**AMENDMENTS TO THE DRAWINGS**

Amendment dated February 23, 2006

After Final Office Action of November 23, 2005

**REMARKS**

FIG. 4

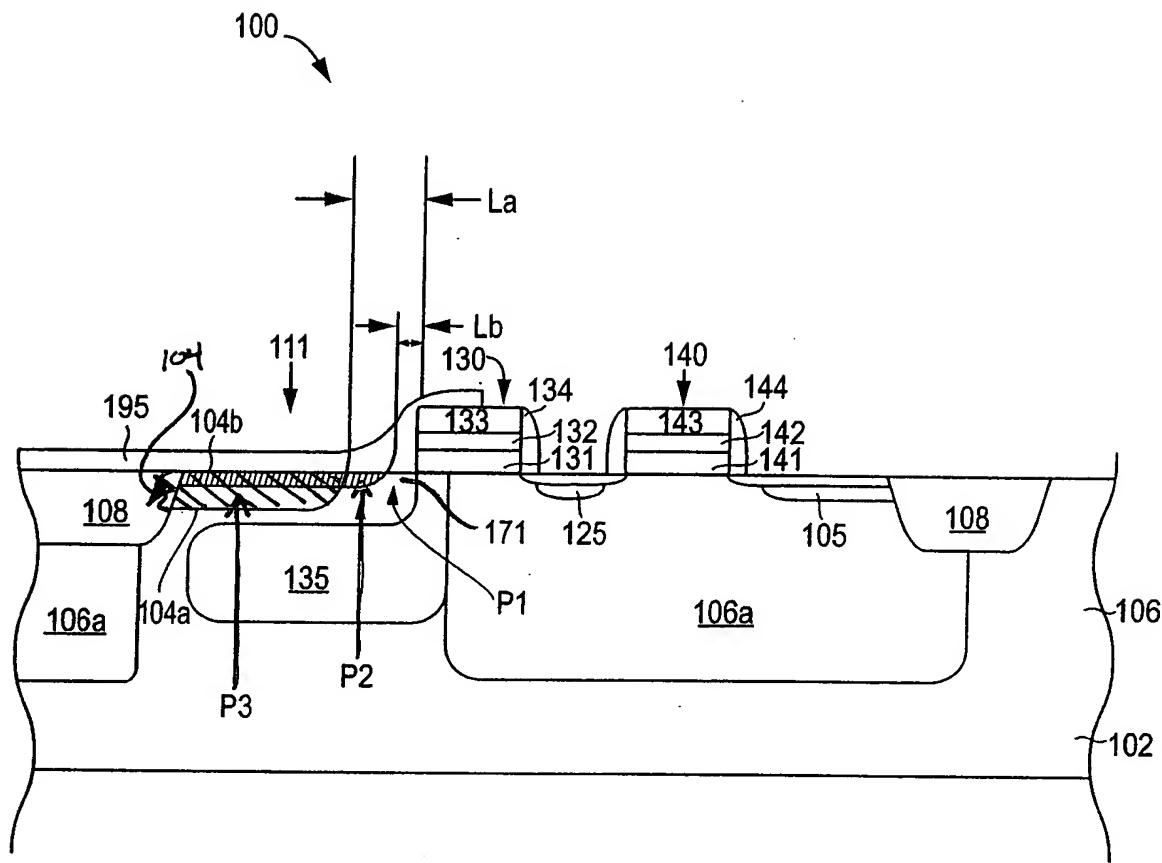
The drawings stand objected to under 37 C.F.R. § 1.83(a). The objection is respectfully traversed. The amendment to the claims and the replacement of FIGs. 4, 5D, 5E, 5F, 5G, 5H, 6, 7E, 7F, 7G, 7H, 8, 9F, 9G, and 9H overcomes the objection. The objection is respectfully requested to be withdrawn.

The specification at, *inter alia*, paragraphs 86 through 94, and specifically paragraph 90, instructs that region 104a, for example as shown in FIG. 4, is formed so that it reaches into the substrate (102) from its surface toward an underlying charge accumulation region (135). The specification discloses that region 104b, a second implant region, is formed partially overlapping with region 104a, making that overlapped part of region 104a, which is near the substrate surface, even more concentrated with dopant than other parts of region 104a deeper within the substrate.

For example, paragraph 90 of the specification states, “[i]t should be appreciated that portions of region 104a is further doped with the dopant ions used to form region 104b. As a result, the top surface of region 104a has a higher dopant concentration than the 104a region found deeper within substrate 102.” This structure is illustrated by FIGs. 4 and 5E-5H, and in similar layout in FIGs. 8, 9G, and 9H. Therefore, the Office Action (page 5) assertion that the recited “a doped region in said substrate and at said surface thereof” having “a graded profile, wherein said doped region has a higher dopant concentration near the surface of the substrate” is not disclosed in the specification is incorrect and the rejection of claims 1-29 under 35 U.S.C. § 112, first paragraph, is respectfully requested to be withdrawn.
